TVA-WBN-TS-99-013 10 CFR 50.90

WATTS BAR NUCLEAR PLANT (WBN) - UNIT 1 - TECHNICAL SPECIFICATION (TS) CHANGE NO. WBN-TS-99-013 - ALTERNATE STEAM GENERATOR TUBESHEET REGION PLUGGING CRITERION (F*)

PROPOSED TECHNICAL SPECIFICATION (TS) CHANGE WBN-TS-99-013
DESCRIPTION AND EVALUATION OF THE PROPOSED CHANGE

TUBESHEET AREA FOR F* CRITERION

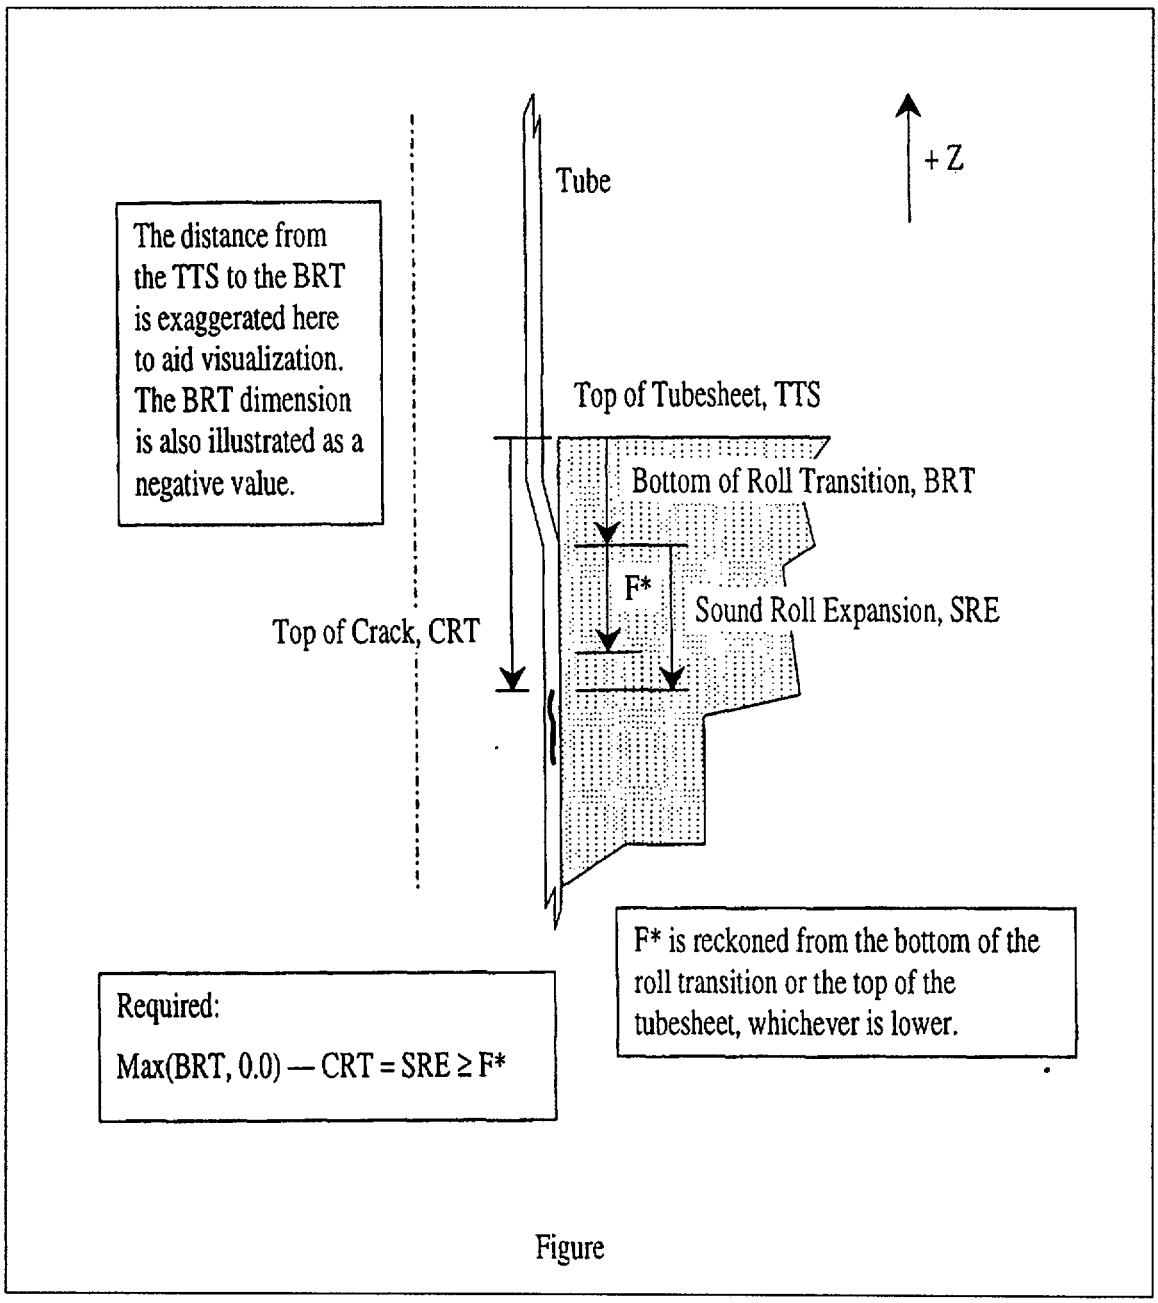
The proposed license amendment requests NRC's approval to use an alternate repair criteria F* (pronounced F-Star) in the tubesheet region of the steam generator. The F* criterion addresses the action required when degradation has been detected in the top of the mechanically expanded portion of steam generator tubes within the steam generator tubesheet. (See attached Figure) Existing tube repair or plugging criteria do not take into account the effect of the tubesheet on the external surface of the tube. The presence of the tubesheet will enhance the integrity of potentially degraded tubes in that region by precluding tube deformation beyond the expanded outside diameter. An axial length of sound roll expansion equal to the F* length at the top of the tube/tubesheet roll expansion provides sufficient structural integrity to preclude pull out of the tube due to pressure effects, even after assuming that the tube has experienced a complete circumferential severance within the tubesheet region, at or below the bottom of the F* distance. This same axial length of roll expansion of the tube into the tubesheet also provides a barrier to significant leakage for through wall cracking of the tube in the expanded region.

The proposed change designates a portion of the tube for which tube degradation of a defined type does not necessitate remedial action, except as dictated for compliance with tube leakage limits as set forth in the WBN Unit 1 Technical Specifications. As noted above, the region of the tube subject to this change is in the expanded portion of the tube within the tubesheet of the steam generators. The length of mechanical expansion required to prevent pullout for all normal operating and postulated accident conditions, designated F*, has been determined to be 1.06 inches.

On the basis of this evaluation, it was determined that tubes with any tube degradation within the tubesheet region below the F* pullout criterion (1.06 inches) could be left in service. This specified distance did not include an allowance for eddy current uncertainty in locating the elevation of an indication. An evaluation of eddy current measurement uncertainties was performed for WBN Unit 1 for use in applying the F* alternate plugging criterion. NDE measurement uncertainty lengths are provided for three types of eddy current probes. By adding these NDE measurement uncertainty values to the limiting F* value of 1.06 inch, the evaluation provides F* distances that include NDE uncertainty for three types of eddy current probes, as follows:

Depending on the probe type used for inspection, tubes with degradation which is located a distance of less than the above F* values below the bottom of the roll transition or the top of the tubesheet (whichever is lower in elevation) should be removed from service by plugging or repaired in accordance with plant technical specification requirements.
